0 001 510 .. - QB 24V 9PS  
Alteration to drive spindle

VDT-I-001/107 B  
Ed. 1 7.1975  
Translation of German  
edition of 19.5.1975

**Modification to multiplate clutch  
and pole-shoe mounting**

VDT-I-001/122 En  
5.1978

Fig. 1 old type

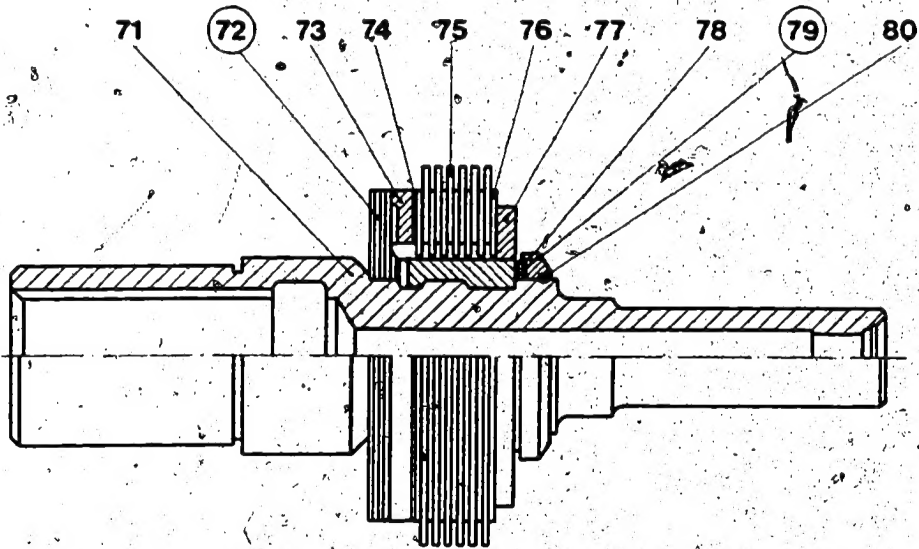
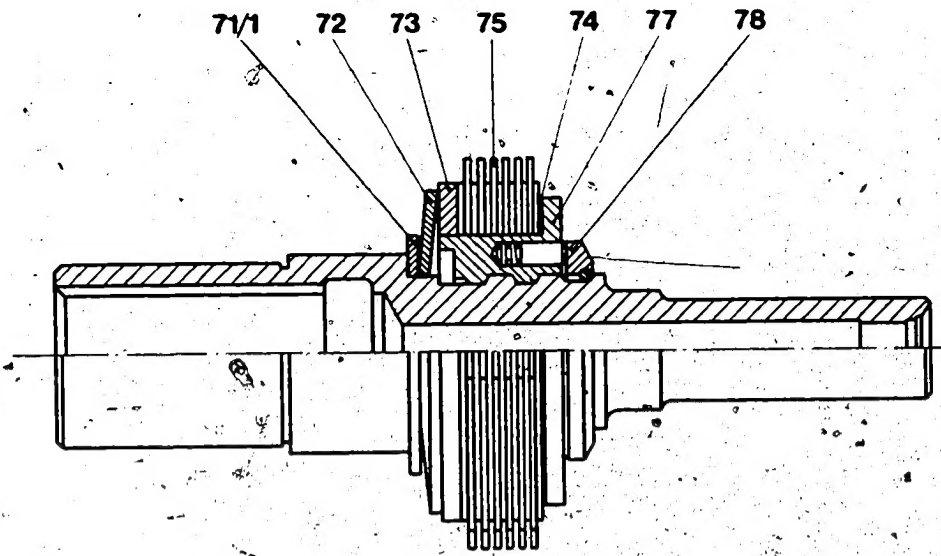
The new drive spindles are interchangeable with the old. The 4 spring washers (pos. 72) have been replaced by a conical spring washer. The spring washer (pos. 79) between the coupling nut and the stop ring has been replaced by 4 helical compression springs and 4 straight pins in the pressure sleeve. Apart from this, the shims (pos. 74) are no longer mounted between the last steel clutch disc and the thrust ring, but rather between the clutch collar and the first steel clutch disc.

The installation positions of the conical spring washer (pos. 72); the helical compression springs with the straight pins, the shim (pos. 71/1) and the shims (pos. 74) can be seen from the section drawing (fig. 2).

Fig. 1 Multiplate clutch

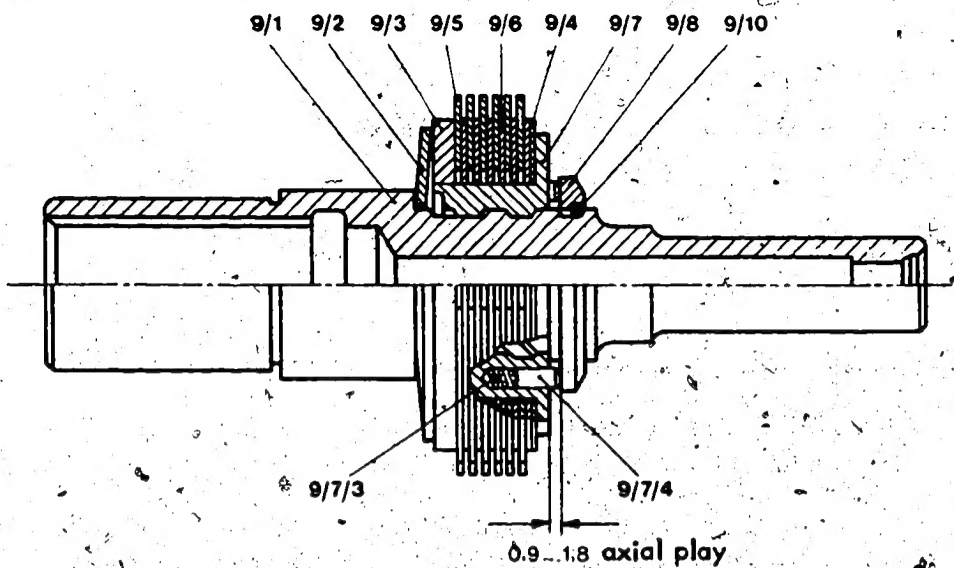
- 1.1. The complete multiplate clutch remains unchanged in terms of installation. The following components are modified (see Figs. 1 ... 3 and the specified item numbers on the service-parts microfiche):

- 1.2. Armature shaft (Item 9/1) : The length of the disc spring seat changes from 5.5 to 4.5 mm, the seat diameter being 30.9 instead of 30.2 mm (Fig. 3). There is no change in the disc spring (Item 9/2).

- 1.3. Coupling plate (Item 9/3) : The thickness of the coupling plate is increased from 3.4 to 3.6 mm, the plate being designed as a friction plate. Consequently, one steel plate is no longer required, so only 6 steel plates must be used with the new drive spindle.

- 1.4. Shims (Item 9/4a...g) : The inside diameter of the shims is increased from 45.5 to 46 mm.
- 1.5. Coupling plates (Items 9/5 and 9/6) : The thickness of coupling plates Items 9/5 and 9/6 is increased from 1.2 to 1.45 and 1.4 mm respectively.

- 1.6. Coupling half (Item 9/7) : The coupling half is now extruded, its diameter being 46 mm (Fig. 2). There is no change in the helical compression springs (Item 9/7/3) and straight pins (Item 9/7/4).

- 1.7. Stop ring (Item 9/8) : The width of the stop ring is reduced from 4.8 to 3.8 mm.

Fig. 6 New type

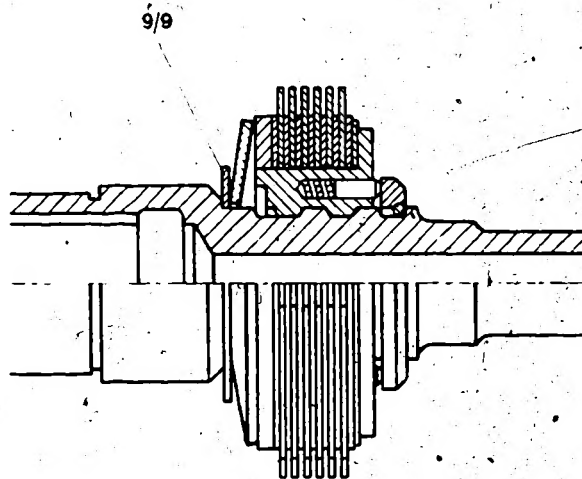
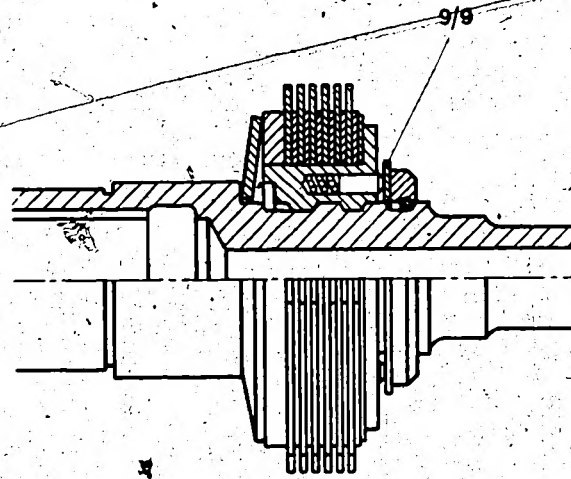
The shim (Item 9/9) must be fitted in accordance with Fig. 6 when carrying out repair work on the new multiplate clutches, and according to Fig. 5 (clutch chamfered) in the case of old-type clutches.

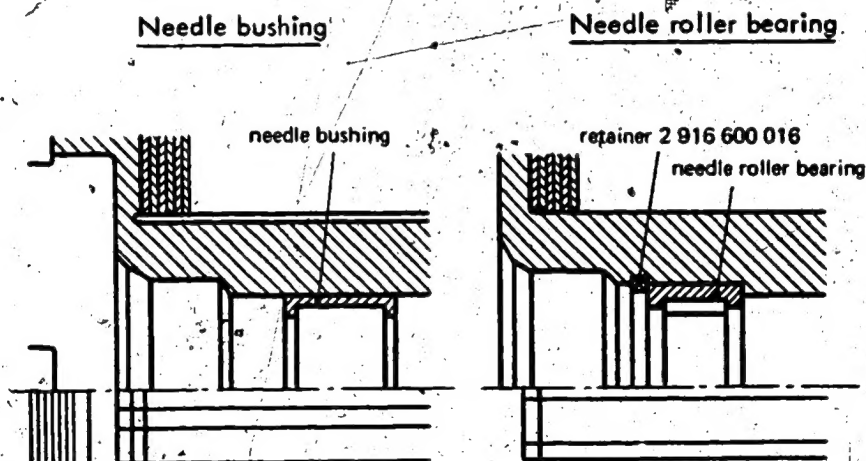
As from FD 521 (date of manufacture January 1975), only armature types with needle roller bearing and retainer will be manufactured for "T" starting motors, the part number remaining unchanged.

The part number of the needle roller bearing is changed from 1 900 910 109 into 1 000 910 002. The needle bushing 2 000 910 003 can still be obtained through your authorized representative.

Needle roller bearing and sleeve are not interchangeable.

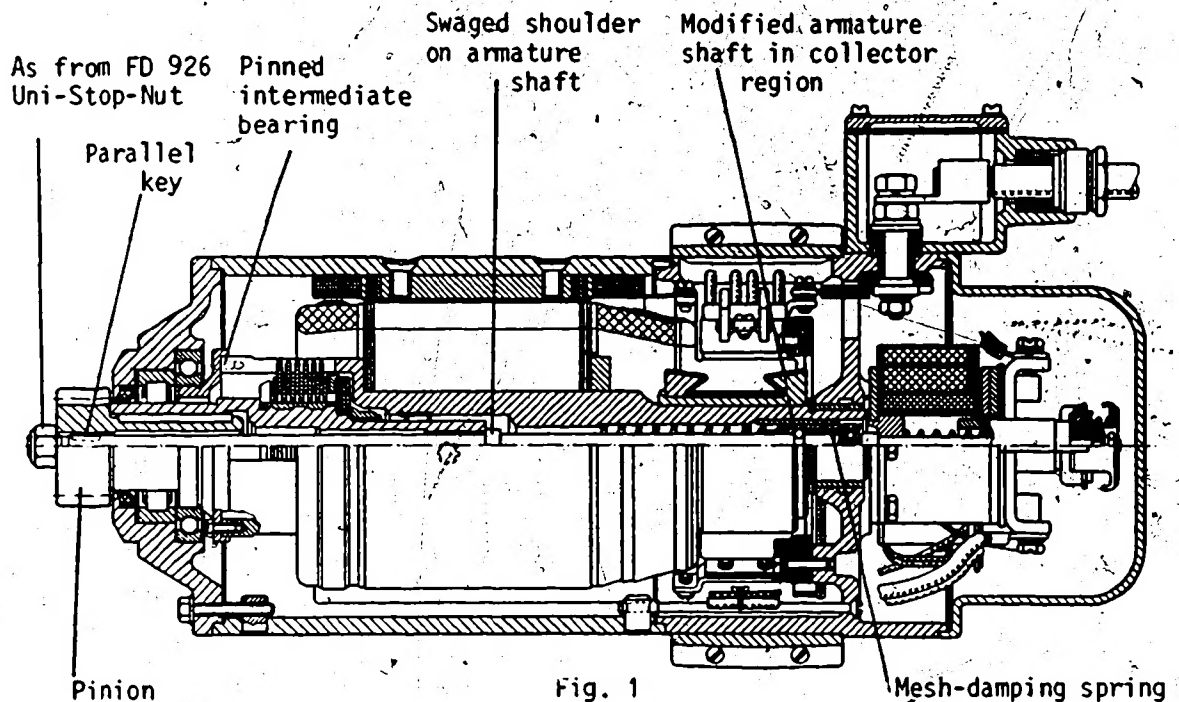
Up to date of manufacture FD 821 (Jan. 78) the engagement rods were delivered with a locking washer, a slot in the threaded section and a pinion-securing nut (Uni-Stop-Nut). When repairing engagement rods of this type, a new locking washer (1 000 146 001) and a Uni-Stop-Nut 2 003 315 002 (M 10x1.5) or 2 003 315 000 (M 10x1) depending upon the thread in question, are to be fitted.

As from FD 822 (Feb. 78) the following modification has been carried out: The slot in the threaded portion is omitted. In its place a 3 mm wide slot was introduced for a parallel key behind the threaded section. This serves as protection against the rod turning relative to the pinion. For this purpose, the pinion was provided with a corresponding slot in its bore.

The engagement rod is now always provided with an M 10x1.5 thread.

The pinion is only secured with the Uni-Stop-Nut 2 003 315 002

The mesh-damping spring has been moved from outside the guide sleeve to inside it.

**IMPORTANT:** When repairing an old starting motor using a new engagement rod (modification as from FD 822) it is necessary to fit a new pinion. On the other hand new pinions (with a slot in the bore) can be used as well for the old-type engagement rods (with locking washer).

A new Uni-Stop-Nut is always to be used when carrying out repairs and tightened with a torque of 35 ... 45 N·m (3.5 ... 4.5 kgf·m).

Fig. 2

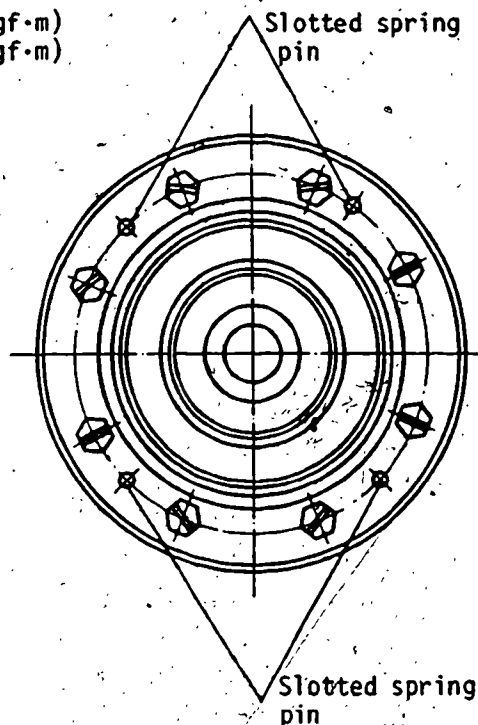
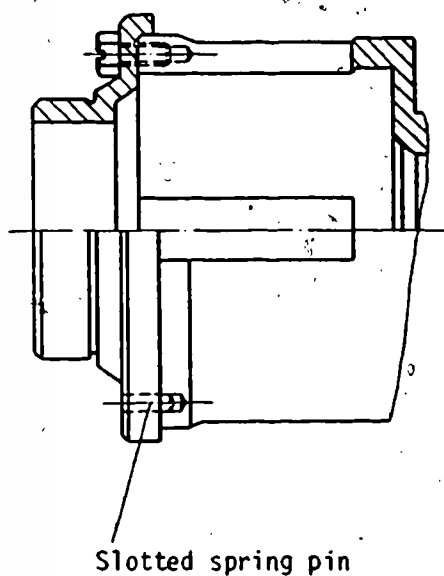
3. Pinning of intermediate bearing (Fig. 2)

In several cases during starting-motor repair it has come to light that the intermediate bearing fitted to the drive housing is no longer correctly fastened.

As a remedy - only for these special cases - the intermediate bearing is also pinned with 4 slotted spring pins. These pins are included in the Service-Parts list. They are included with the intermediate bearing on new armatures.

The designation of the intermediate bearing is changed from 2 005 857 016 to 1 005 857 030.
